Sheet: /		Engineer: Justin Knapp
File: Pokeball_xs.kicad_sch		
Title: PokeballXs		
Size: A4	Date: 8/25/2022	Rev: 1
KiCad E.D.A. kicad (6.0.5)		Id: 1/1

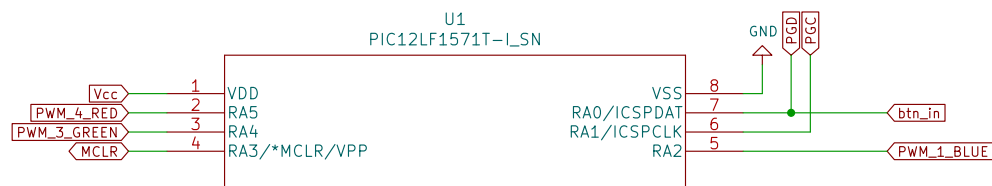
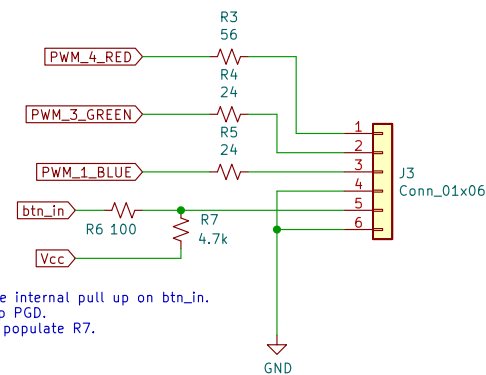
ID might need to be floating instead of connected to ground.

Might need to use internal pull up on btn_in.
Vcc might pull up PGD.
Maybe just don't populate R7.
